# BULLETIN

Bulletin No. 103

**SUBJECT:** Shock Strut Stop Discs

**TO:** Owners of J3 Series Airplanes Incorporating Landing Gear Approved For 1220 Lbs. Gross Weight and PA-11 Airplanes Serial Nos. 11-1 to 11-352 incl., 11-354 to 11-357 incl., 11-359, 11-361 to 11-369 incl., 11-371 to 11-375 incl., 11-377 to 11-385 incl., 11-387, 11-396 to 11-402 incl., 11-413, 11-414 and 11-430, also 11-1354 to 11-1474 incl.

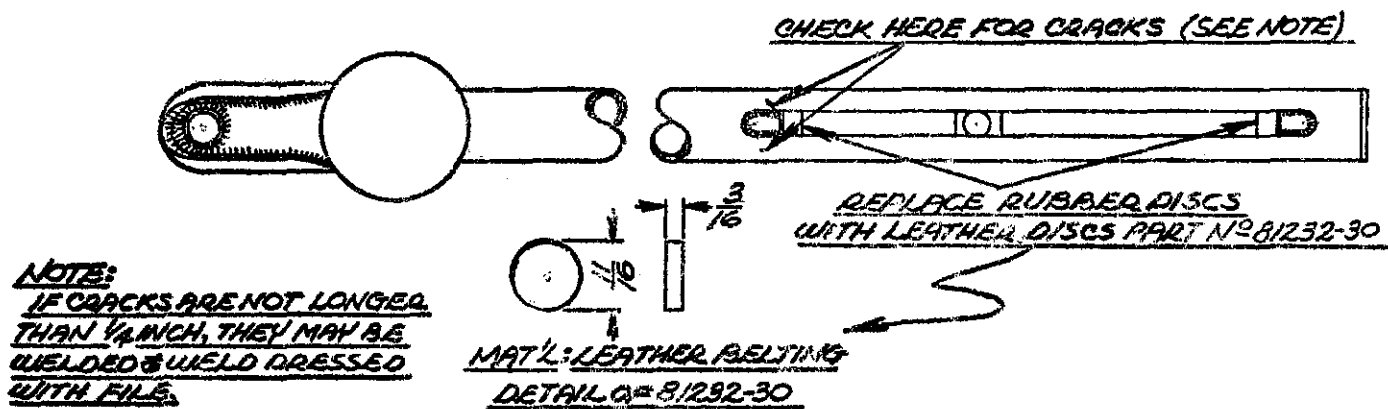
The shock struts of the above listed airplanes incorporate rubber stop discs (Part No. 81232-13) at the ends of the stop bolt slots.

As these rubber discs require frequent replacement in service, and, in some cases, have caused deforming and cracking of the strut tube, it is recommended that they be replaced with leather discs (Part No. 81232-30) at the next periodic inspection, or when maintenance of the landing gear is necessary.

Parts 81232-30 are available from your Piper distributor, or may be made from belting leather.
